FLOREO AT TERAVALIS

SUN VALLEY PKWY PAVING PLAN

07/19/2023 - ORIGINAL RIPRAP CHANNEL HAS BEEN REVISED TO A SOIL CEMENT CHANNEL, PROVIDING RESHAPING TO CONTOURS ALONG THE ENTIRE CHANNEL ALIGNMENT.	
PLAN NAME FLOREO AT TERAVALIS COLLECTORS - PHASE 2 BOX CULVERT-PLAN & PROFILE	
ENGINEER INFORMATION HILGARTWILSON	
COB PERMITTING APPROVED SEAL	COB ENGINEERING APPROVED SEAL
AS-BUILT SEAL	DESIGN SEAL
ORIGINAL PLAN DATE Feb-23	LATEST REVISION DATE
PROJECT NUMBER 1175	SHEET NUMBER SD02 17 OF 19
COB PLAN TRACKING # ENG-23-0057	
COB PERMIT # ENG-21-0288

7/17/2023 - REVISION TO CHANNEL ALIGNMENT AND REPLACE RIPRAP WITH SOIL CEMENT

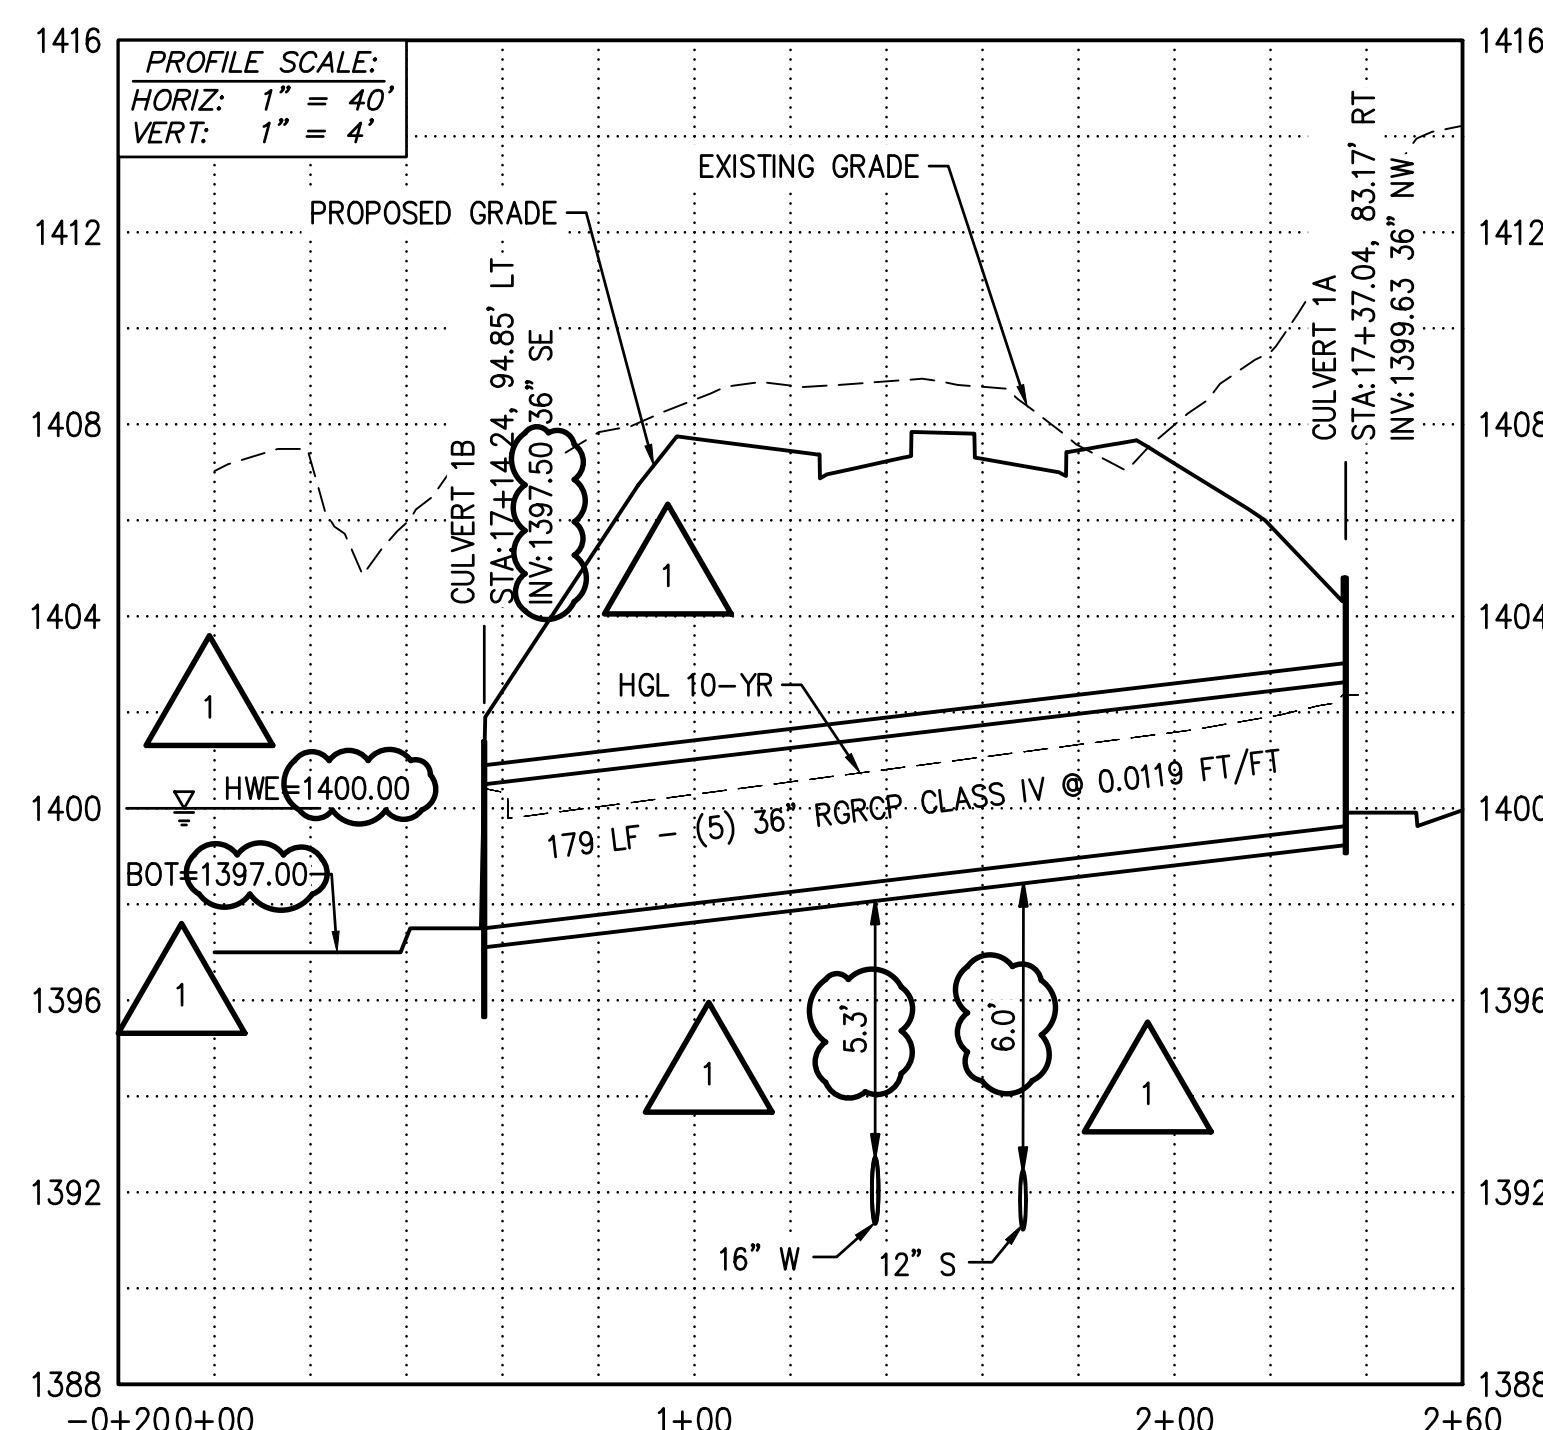
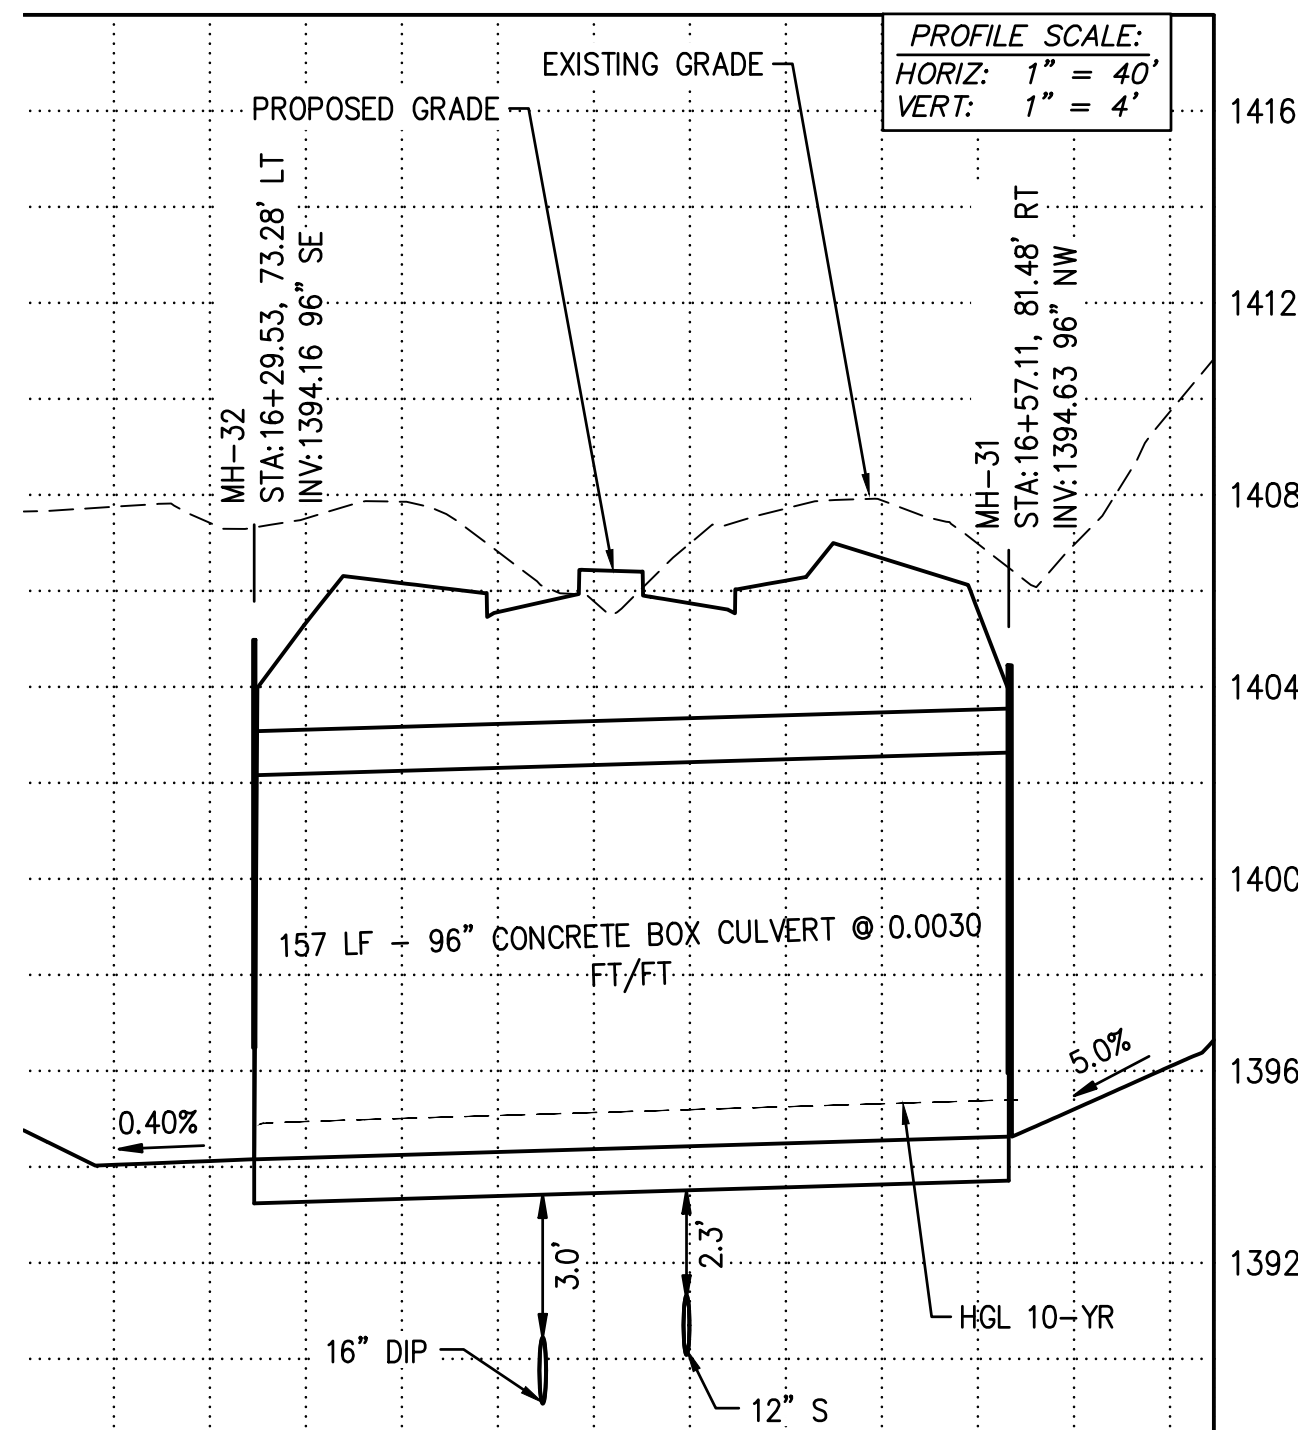
7/17/2023 - REVISION TO CHANNEL ALIGNMENT AND REPLACE RIRAP WITH SOIL CEMENT
